CITY OF ALBUQUERQUE

Re: Las Lomas Plaza, Building 3
2101 Vista Oeste NW
Request for Certificate of Occupancy
Transportation Development Final Inspection
Engineer's/Architect's Stamp dated 8-22-18 (H10D031)
Certification dated 8-23-18

TITLE
Architectural Site Plan

Re: **Permanent Certificate of Occupancy for
Las Lomas Plaza, Building 3 (Phase 1)
2101 Vista Oeste NW**

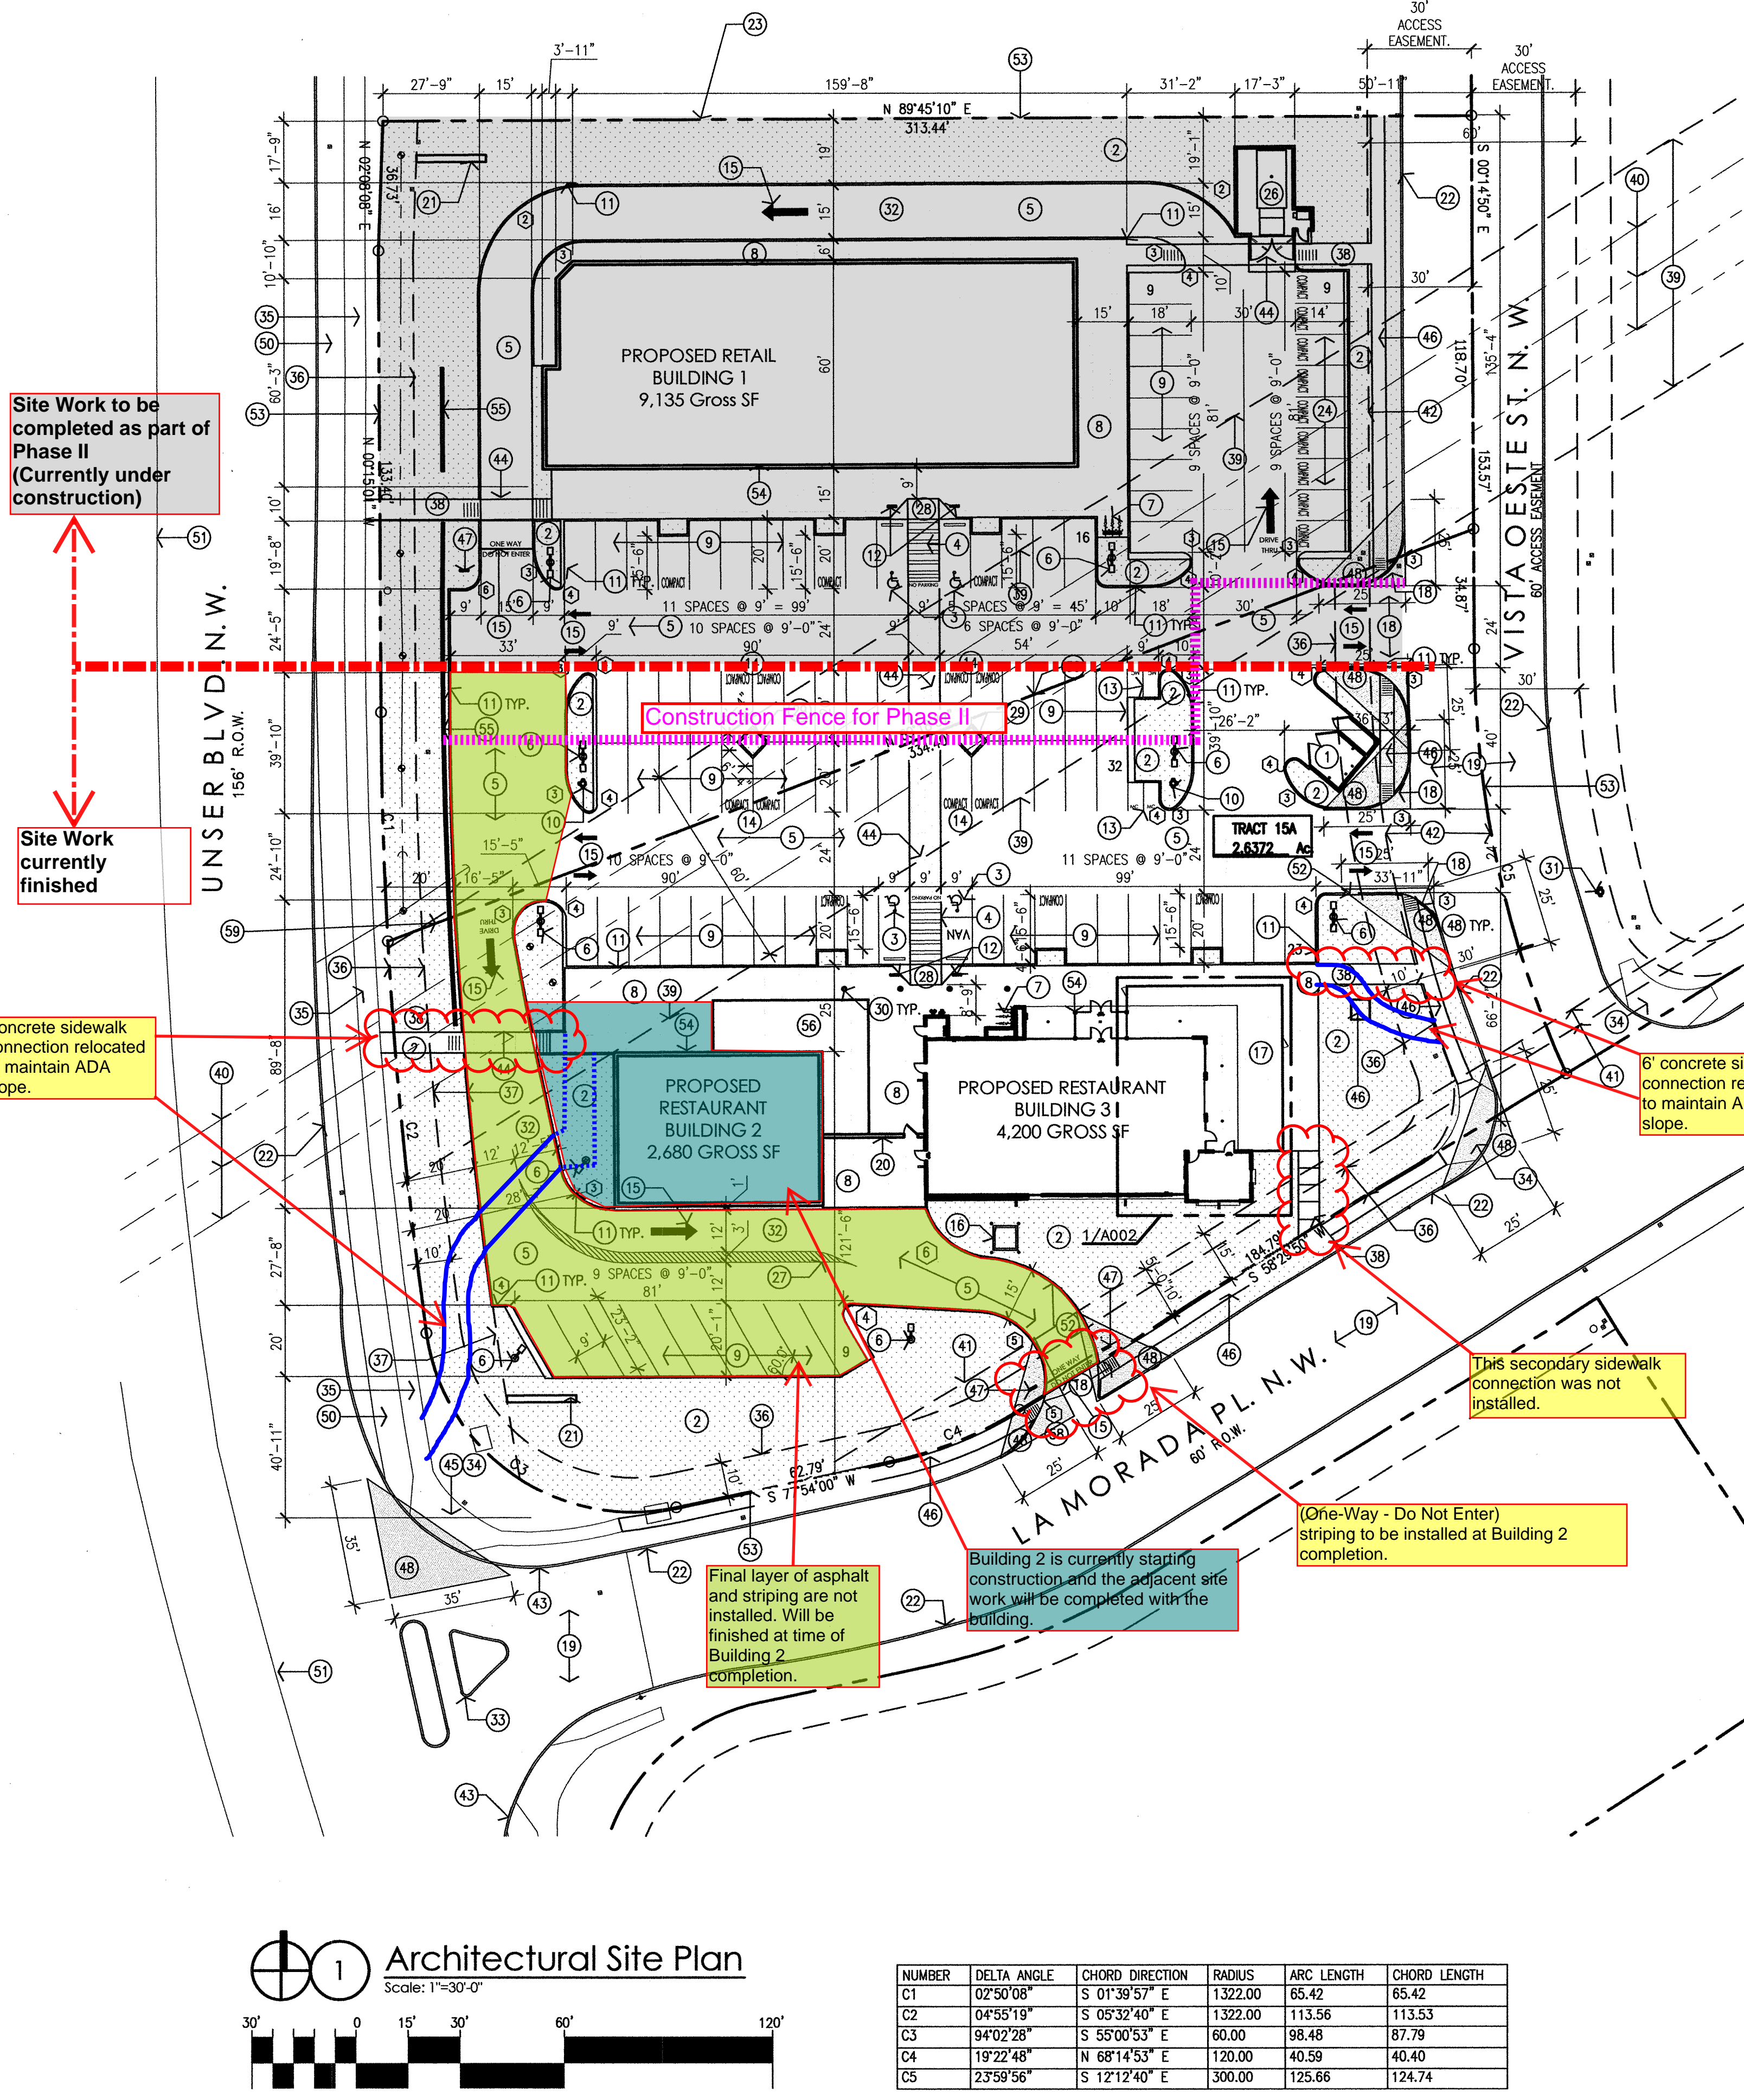
1. Please add truncated domes on corner of Unser & La Morada, and corner of La Morada & Vista Oeste when requesting CO for Building 2.
2. Please add sidewalk connection off Unser to Building 2 when requesting CO.
